# Department of Public Health

## On-Site Wastewater Treatment System (OWTS) - Installation Inspection

Address: 5692 Pittsford Palmyra Road

## CONSTRUCTION PERMIT FOR THE RESIDENTIAL REPAIR OF AN ONSITE WASTEWATER TREATMENT SYSTEM

### Sketch

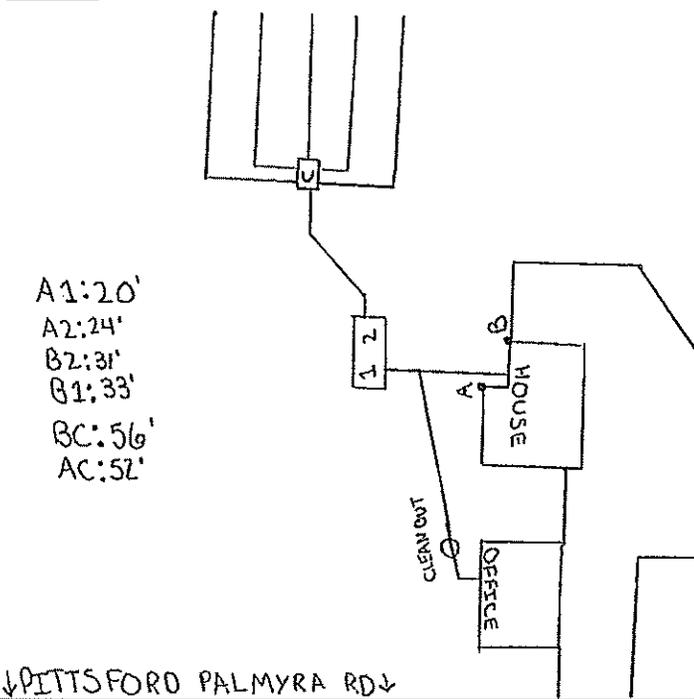
-System functionality may be impacted by groundwater. At time of inspection mottled soil was visible on excavation walls near the distribution box, about 2.5 feet deep from ground level. If the system experiences failure due to ground water or drains slowly, a pump station and sand bed design may be required
